An Bord Pleanála Reference: Case reference: JA18.314501
314501: Properties at 7- 13 Dublin Street, lands to the rear of 1-9 The Diamond and 1-26 Dublin Street, the Courthouse car park, Lower Courthouse car park, Castle Road, and N54 Macartan (Broad) Road, townlands of Roosky and Tirkeenan, Co. Monaghan

Eddie O’Gara
&
on behalf of Love Monaghan Save Dublin Street

Issued Oct 2022

Submission: Eddie O'Gara CMLI MILI

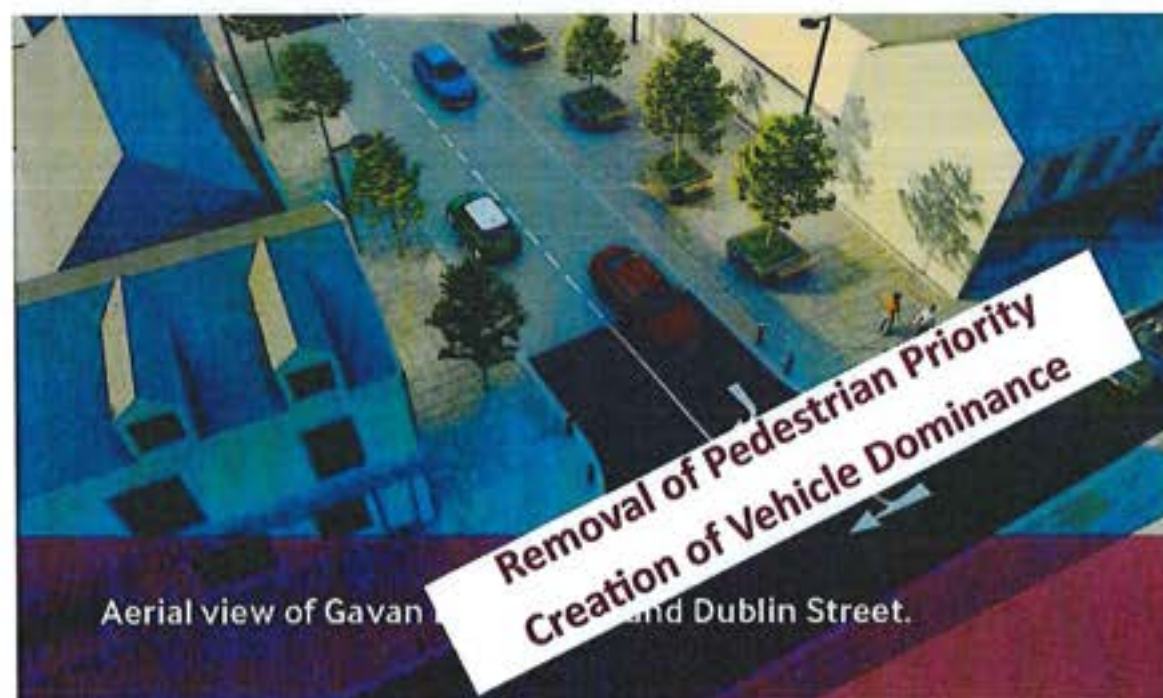
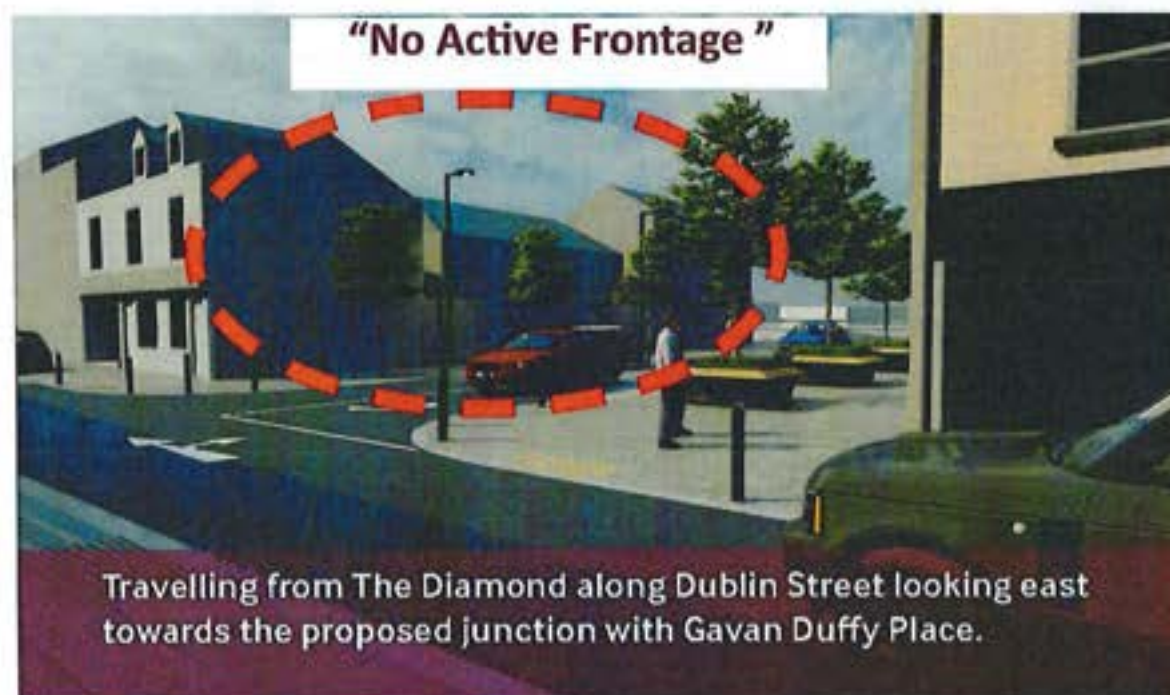
The Sheridan Woods Artist impression hides the reality that this is not place but actually a road. A road without any animation from the building edge and Car Parking!

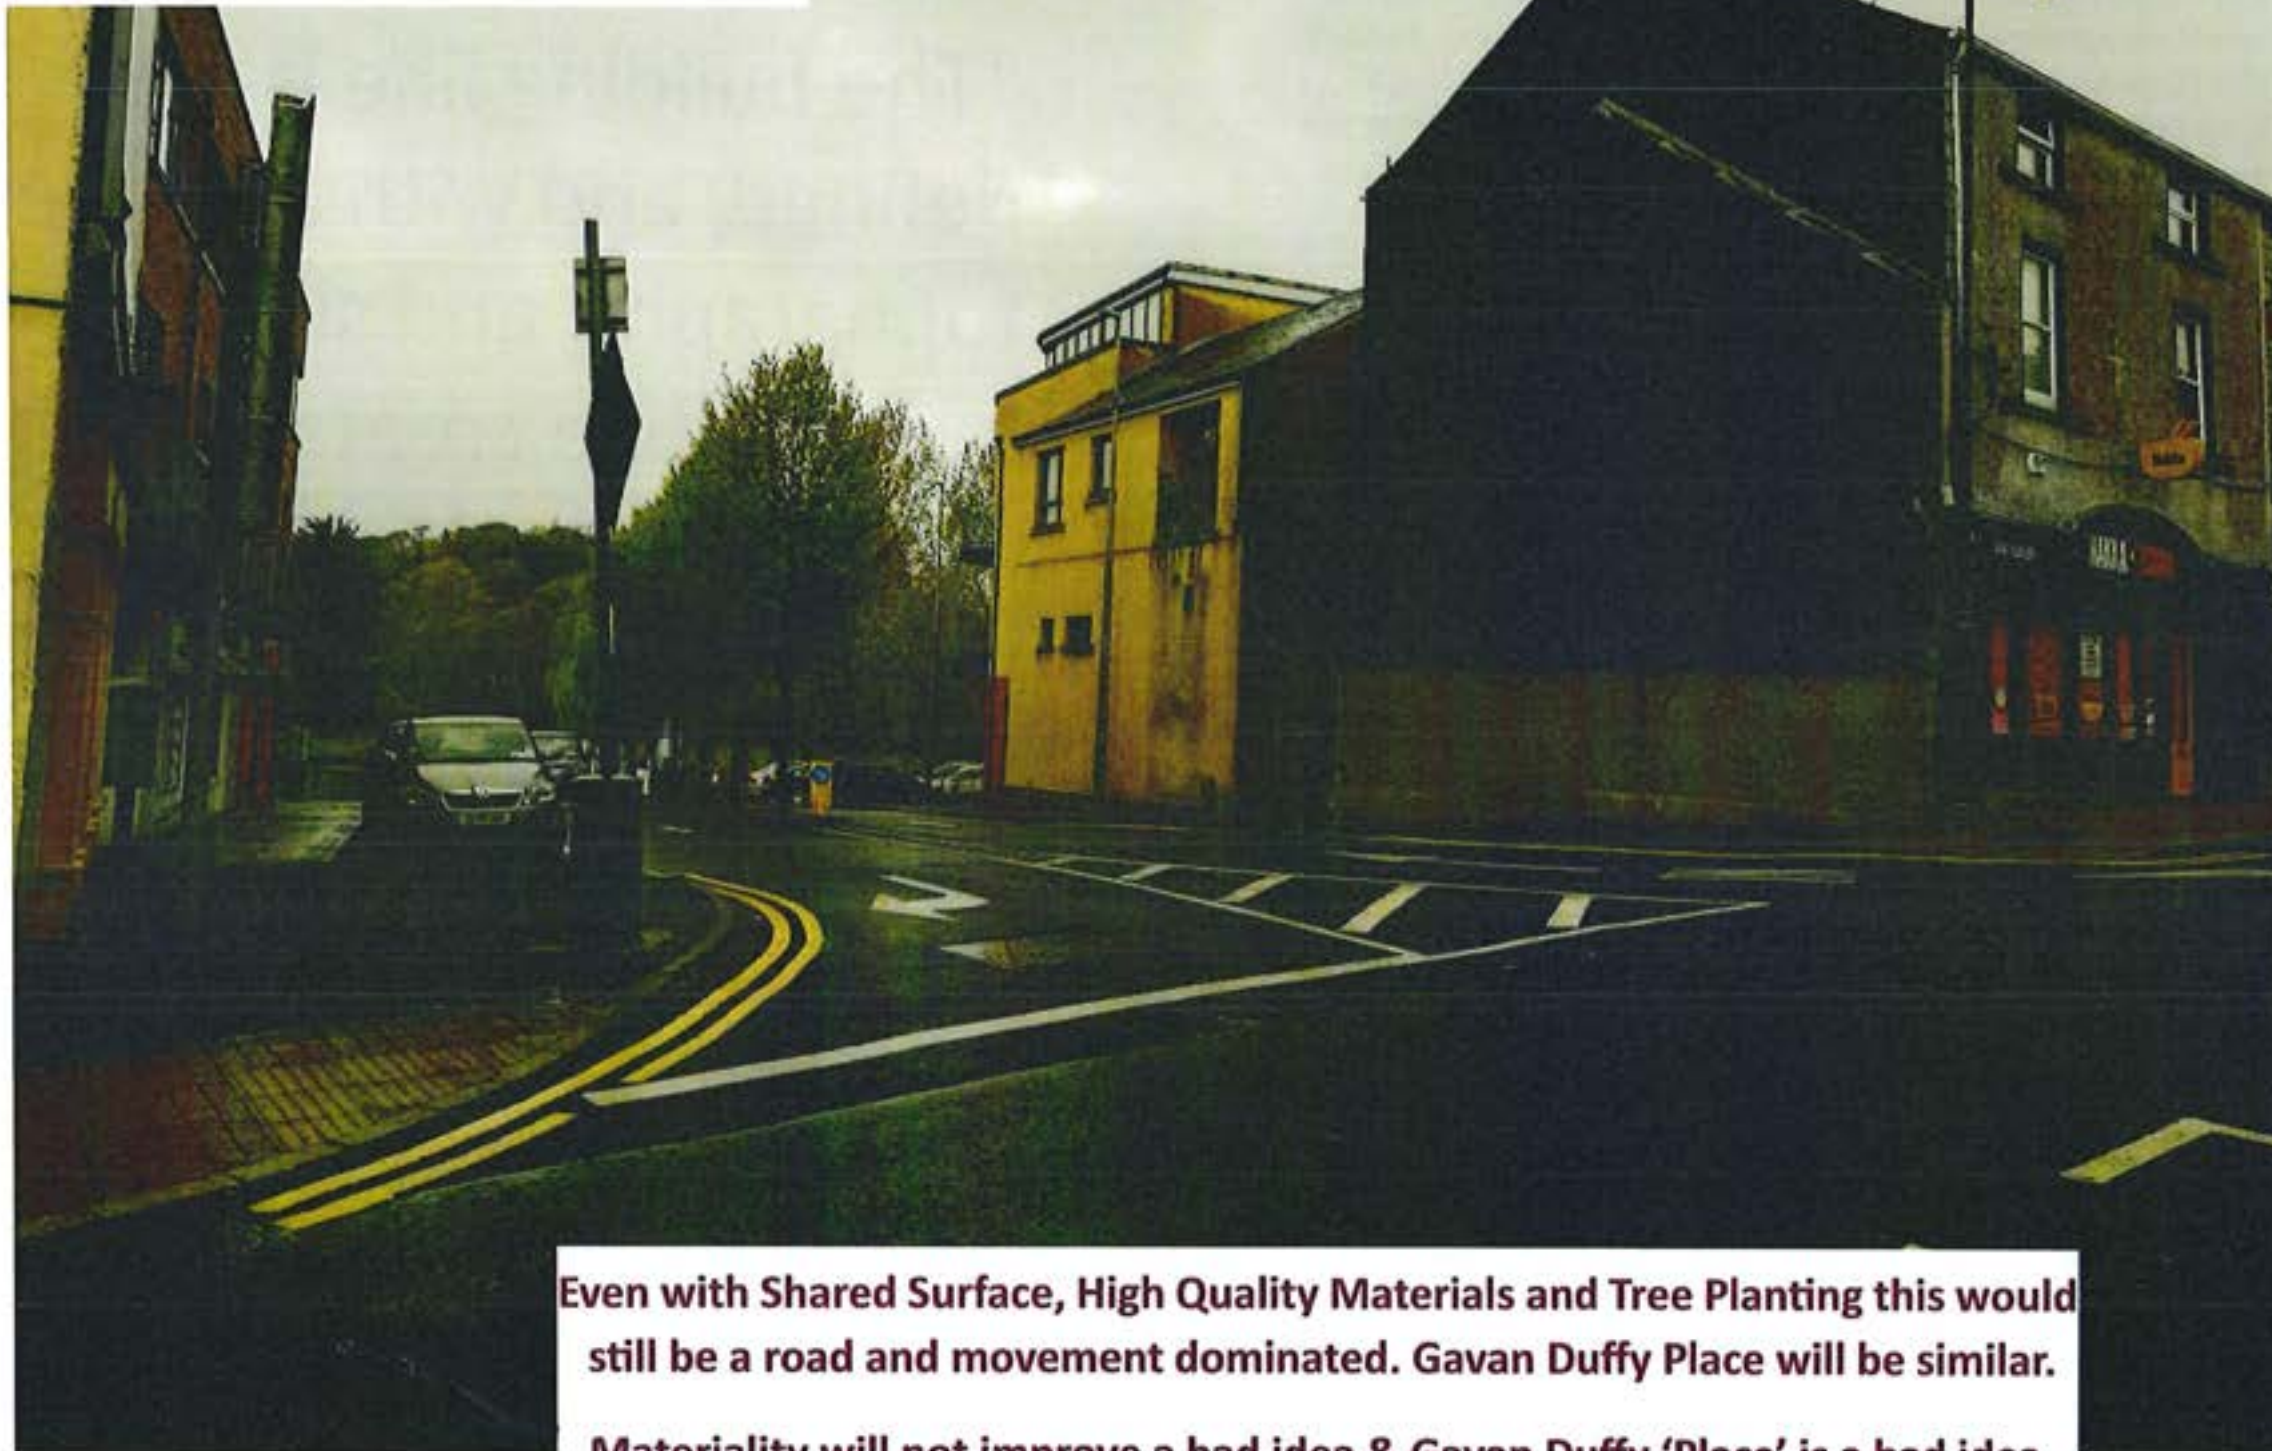
The Sheridan Woods report states about Dublin Street that *"The building line is well defined, and with a gentle rising topography, and slightly curving building line creates an attractive and intimate closing effect."* **This building line will be destroyed as part of proposals to remove 4No. buildings in order to build a new road and will increase the already vehicle dominated and hostile environment on Dublin Street.**

The RPS proposals state *"A raised table (natural stone) will be provided at the junction,*

to slow traffic speed and create a shared surface for pedestrians and vehicles. Uncontrolled pedestrian crossings are proposed." This is somewhat recognising that a new conflict point between vehicles and pedestrians has been created and pedestrian comfort has been further eroded within the town centre. It also now brings vehicles into conflict with pedestrians on the safest side of the street especially for vulnerable users (children, disabled and those with mobility issues)
